November 21, 2016
BOARD OF COUNTY COMMISSIONERS
ORANGE COUNTY, FLORIDA
Addendum No. 2, IFB Y17-713-CC
BARNETT PARK AIR HANDLING UNITS REPLACEMENT

1. Revision: The following attached drawings have been revised:

Project:
Barnett Park AHU Replacement

SECOND FLOOR PLAN - HVAC.
SCALE 1/8" = 1'-0"

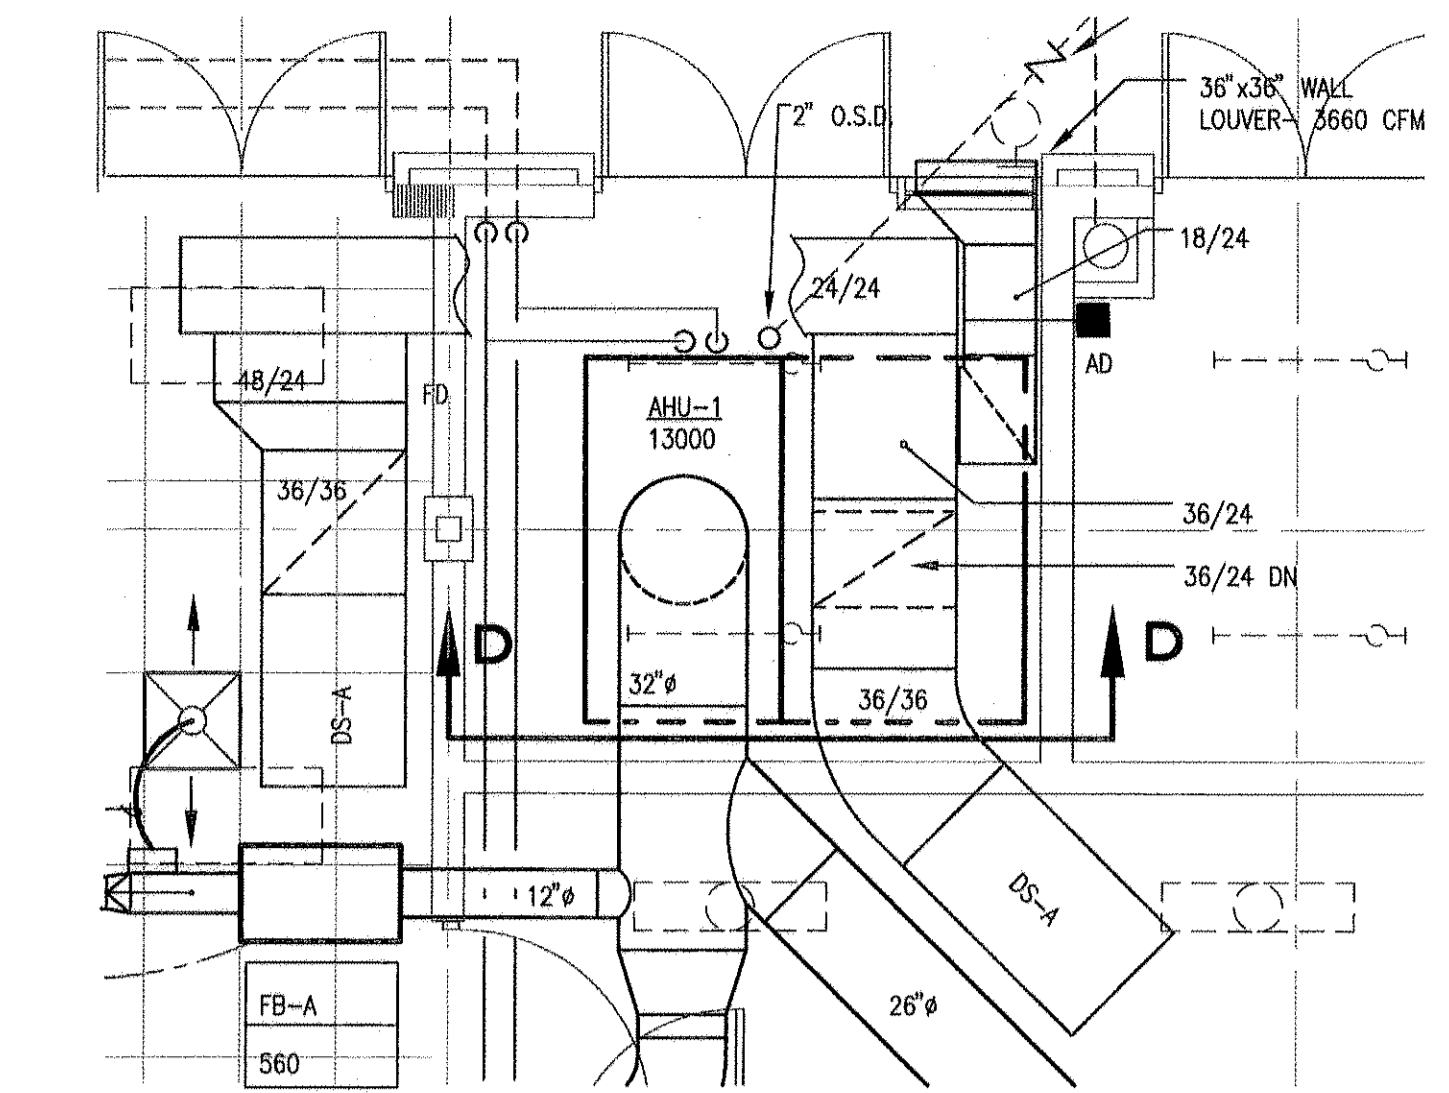
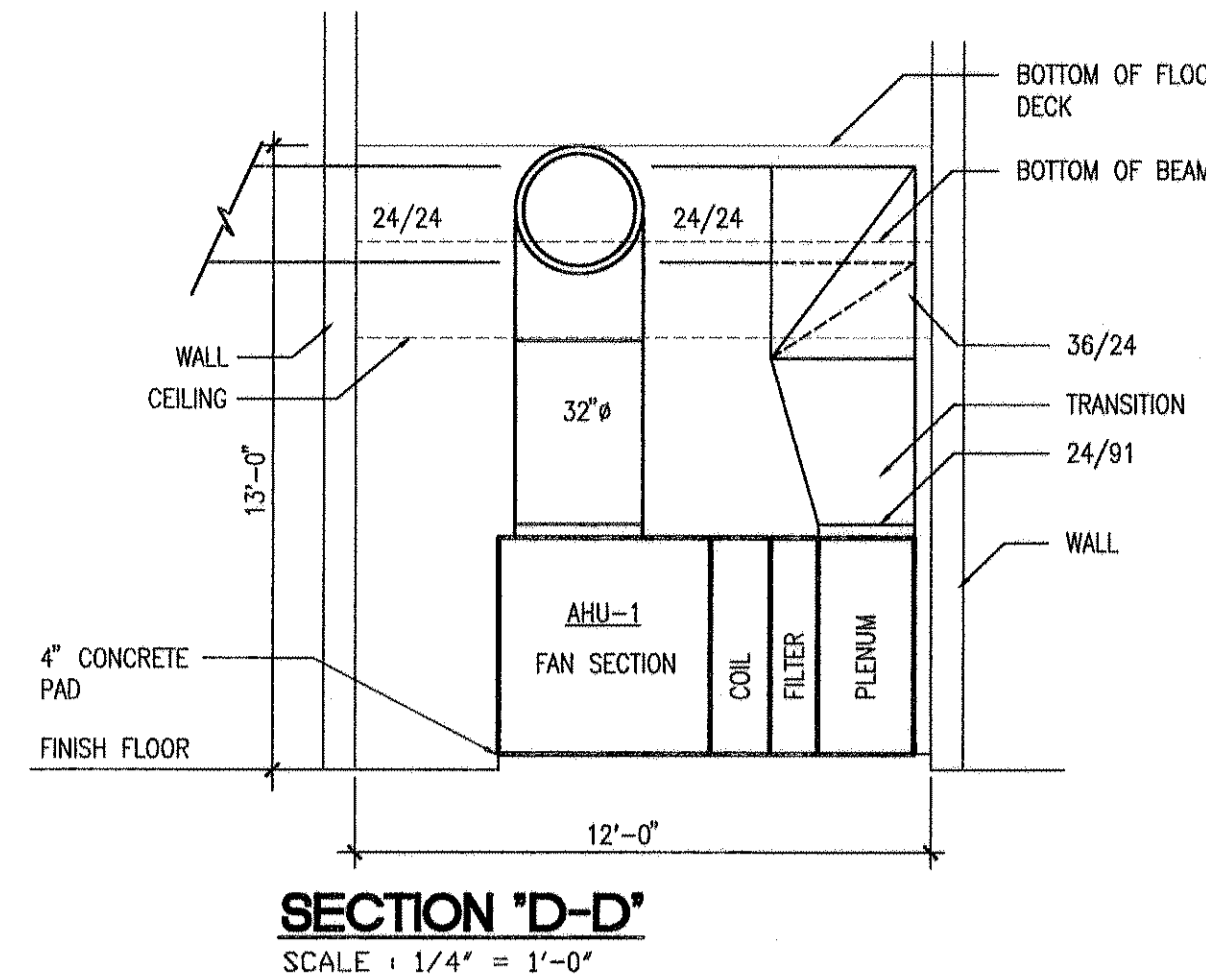
13. Question: Can you provide Architectural Reflected Ceiling as-built drawings for the first and second floor areas indicating replacement of ductwork as shown on M103? Mechanical Drawings do indicate a specific area of a fire-rated ceiling.

Answer: Please see the attached as-built drawings provided for information only (Sheet M-1 dated 5/25/1995, and Sheet M-2 dated 5/25/1995). In addition, per Orange County Facilities Management, these areas are acoustical ceiling tile. Refer to Sheet M403 for fire rated lid construction and location.
